Well Name: BUTTE	Well Location: T30N / R13W / SEC 18 / SWSW / 36.807829 / -108.249421	County or Parish/State: SAN JUAN / NM
Well Number: 4	Type of Well: OTHER	Allottee or Tribe Name:
Lease Number: NMNM09867A	Unit or CA Name:	Unit or CA Number:
US Well Number: 3004533888	Well Status: Abandoned	Operator: HILCORP ENERGY COMPANY

Type of Submission: Subsequent Report Type of Action: Plug and Abandonment

Butte 4
30-045-33888
P&A SR

Action 94157

Current Schematic

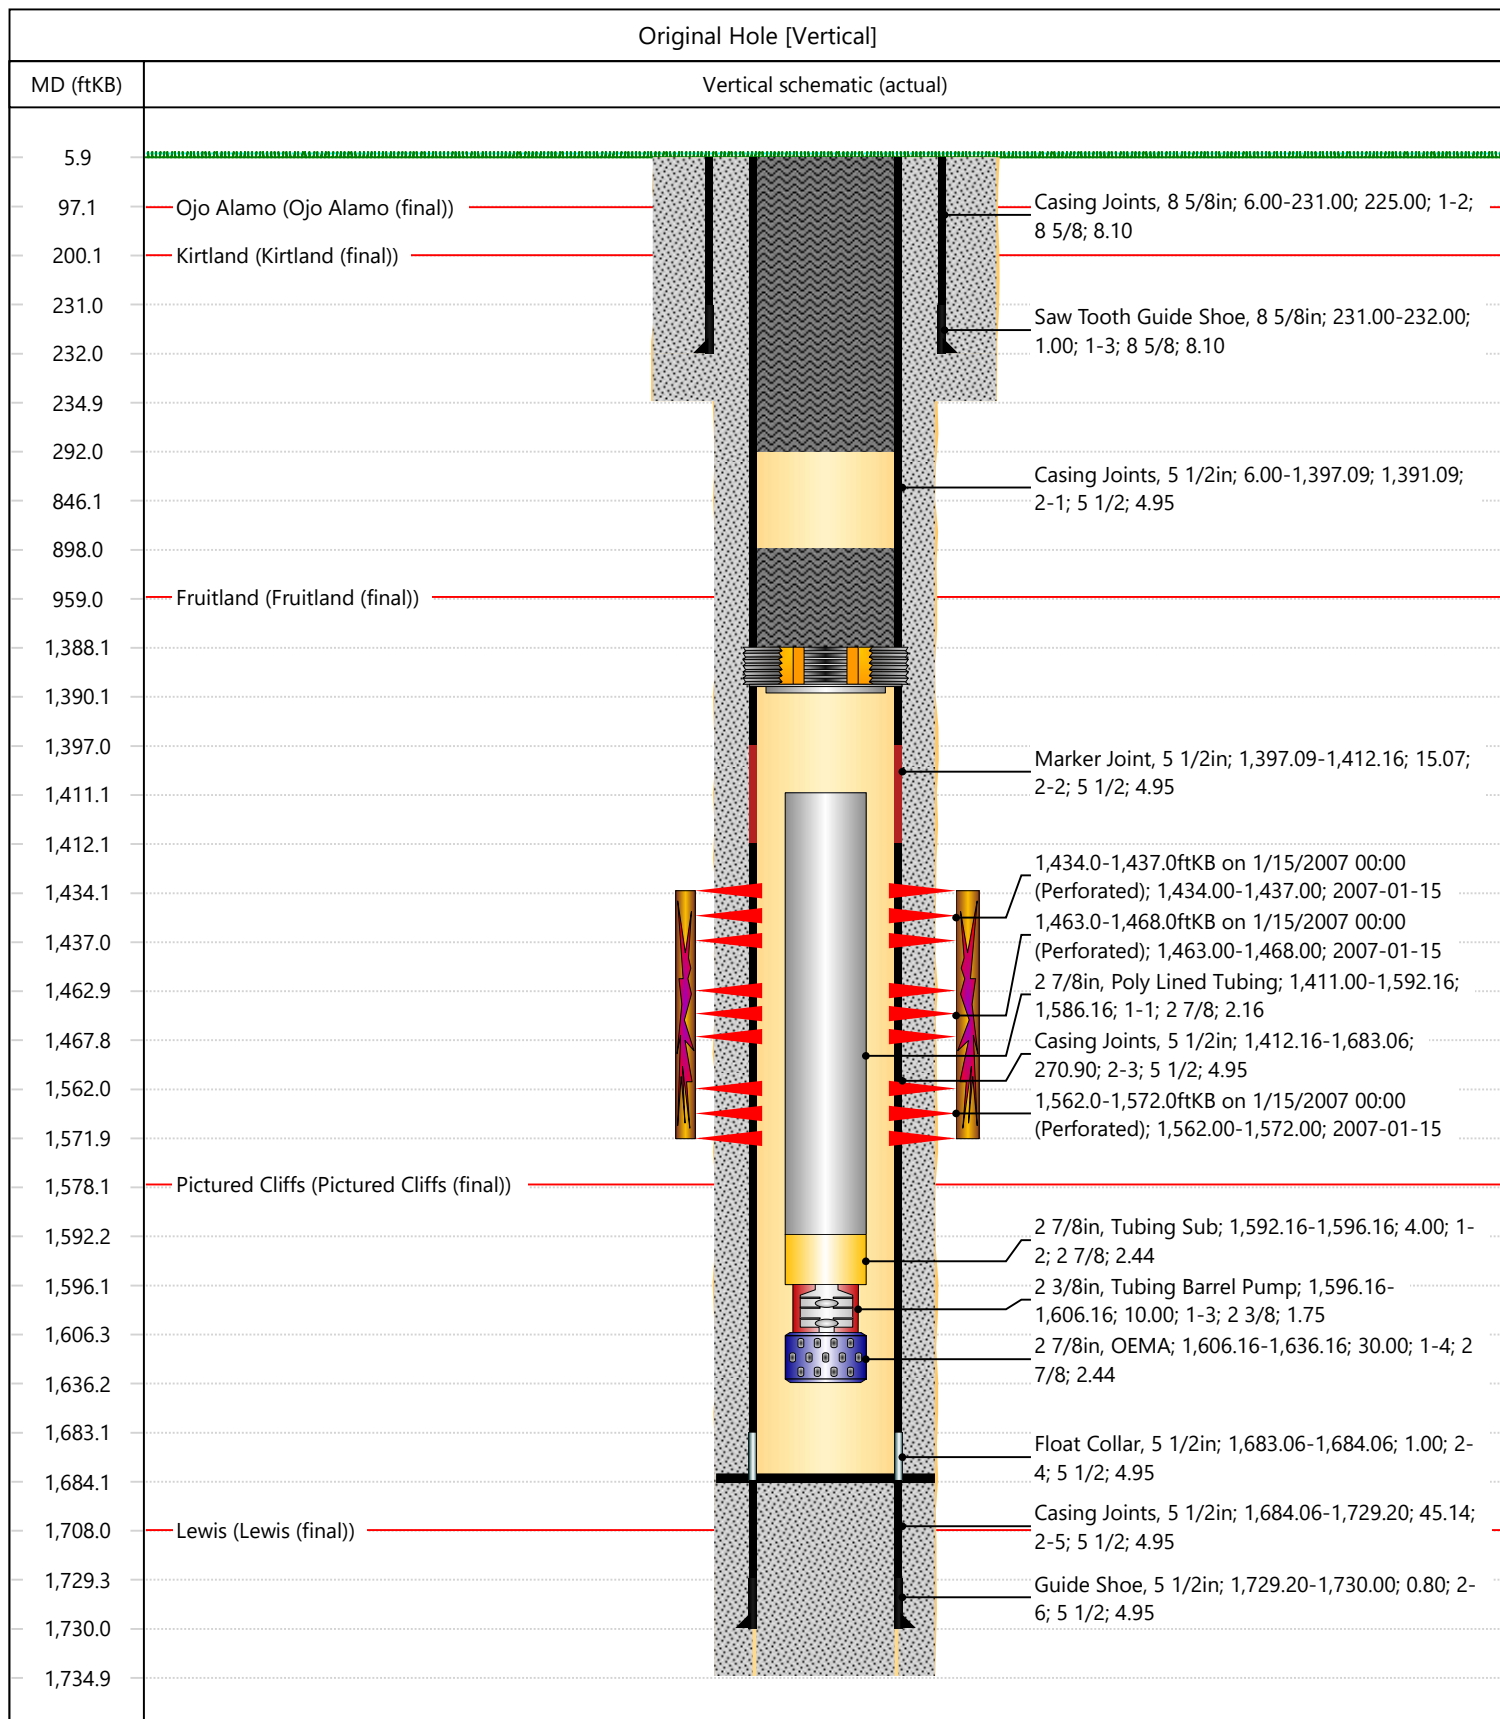
Created By	Condition	Condition Date
mkuehling	Any deviation on an NOI needs approval from all agencies. Non approval from NMOCD could mean the drilling out of a well State/Fee or not.	7/29/2022
mkuehling	"The subject well was plugged and abandoned on 3/11/2021" Statement at end of plugging report shows wrong date of plugging - should be 3/11/2022	8/1/2022
mkuehling	did not receive prior approval from State concerning fish in the hole - Received confirmation from J.P. Knox concerning future compliance 3/23/2022	8/1/2022
